Mark Howe
Business Support Services Officer
Mining Regulation and Rehabilitation Branch
DMITRE
GPO Box 1264
Adelaide SA 5001

Re: Kara Resources Mining Lease MC4322 - Letter of objection and request for further information

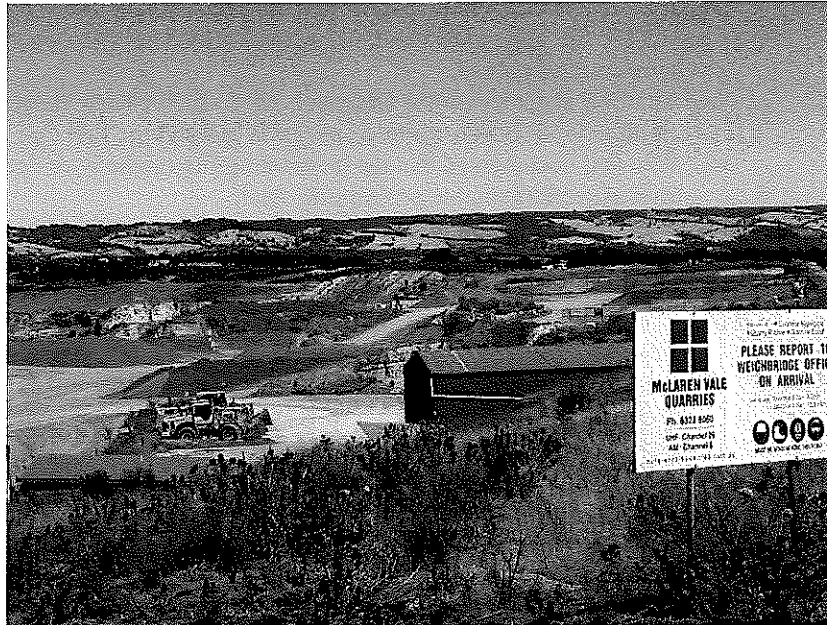
- ii. Criteria: Survey/Inspection results of site will demonstrate weeds or pathogens at the site are at a level or below surrounding pasture levels
- iii. Control Strategies: Enforcement of good housekeeping to eliminate unnecessary disturbance''
- iv. The risk matrix indicate that it is a minor effect and has a cat 2 rare low likelihood of consequences.
- v. The natural process of weeds emerging from the disturbed soil is a certainty when the top soil is placed in bunds similar to the weed and rubbish infested bund on the east side of their mine at McLaren Vale as per following images

- vi. Artichoke thistles are a serious problem in the Nain area as well as Horehound , Sow thistles Marsh mallow, Skeleton weed and Spiny pallenis
 - These seeds can be easily carried by winds to nearby properties.
 - Weed infestation will have a major effect on crop quality and it will cause economic loss and inconvenience for the locals in eradicating them.
- vii. The following photo of the weed infested entrance site at McLaren Vale clearly indicates operations are not conducted in a manner which minimises the spread of weeds and pathogens and unreliable maintenance of the site.
